Error In Design

The Glitch

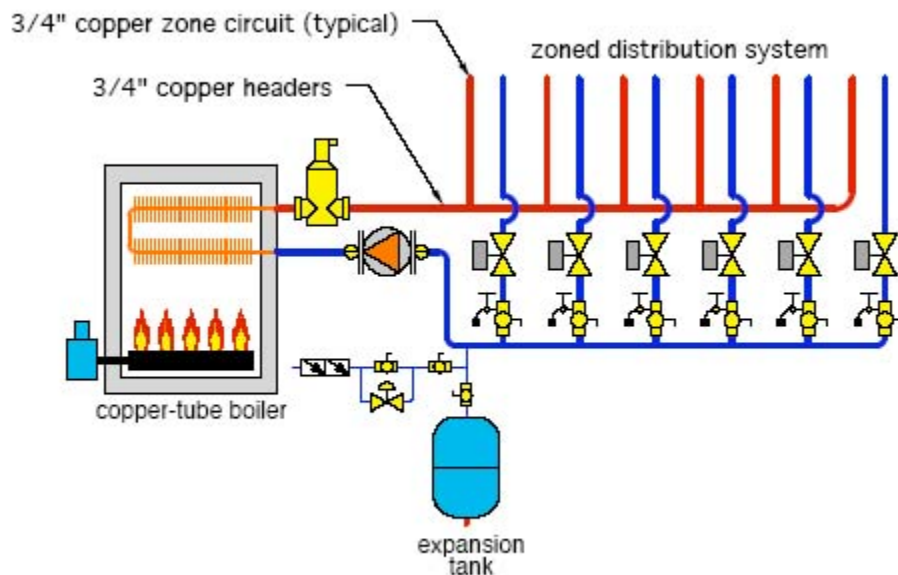
Overview: A copper tube boiler is installed as shown with six zone circuits controlled by zone valves. The installer got a great price on a “contractor pack” of 3/4-inch copper tees, so the supply and return manifolds are built with 3/4-inch copper, as are all the zone circuits. The circulator is installed on the return side of the boiler.

Exercise: There are at least five errors in this design. Can you spot them?

Copper tube boilers are “flow sensitive.” They should not be operated with low flow rates, such as might occur when only one zone circuit is operating.

The correction is to install the boiler as a secondary circuit with its own circulator that maintains constant flow through the boiler regardless of flow in the distribution system.

Other corrections include:

1. Moving the zone valves to the supply side of the zone circuits to prevent heat migration.
2. Ensuring there is at least 12 pipe diameters (12D) of straight pipe on the inlet of all circulators to reduce turbulence.
3. Installing a differential pressure valve to limit differential pressure gain across the headers under partial load conditions.
4. Sizing the headers for a flow velocity of 2 feet/second when all zone circuits are on. This keeps the pressure drop along the header very low and helps prevent changes in zone flow rates as other zones turn on and off.
